Service Bulletin

Bulletin No.: 23-NA-074

Subject: Service Engine Soon (SES), Reduced Power, Service Brake, Reduced Steering and/or Stabilitrak Message Illuminated on Driver Information Center (DIC), DTCs P0232, P023F, P0641, P0651, P06A3, P0697, P07BE, P1000, P1009, P2535, P129D, P12A6, P12A8, P2635, P3051, P3052, P3055, P3056, P305B, U0074, U0077, U0121, U0131, U0151, U0415, U0420, U0672, U111A, U18A2, U18C6, U18D2, U2502, U2616 Set

This bulletin replaces PIT5847H. Please discard PIT5847H.

5874841

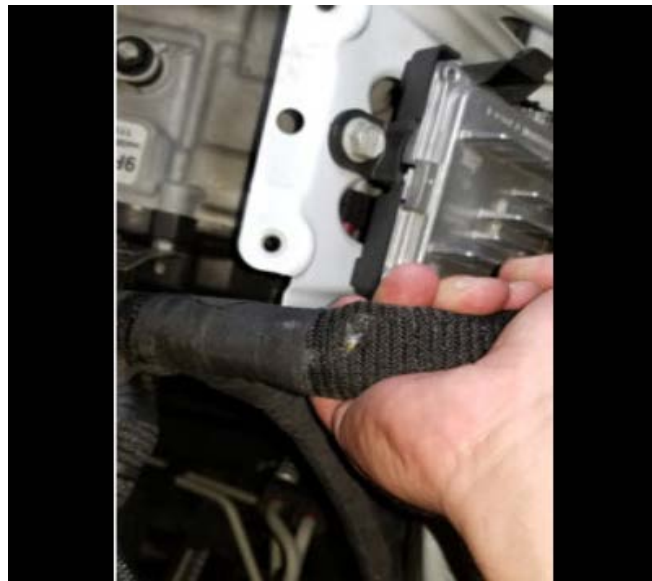
This condition may be caused by wire chafing on the battery tray support bracket.
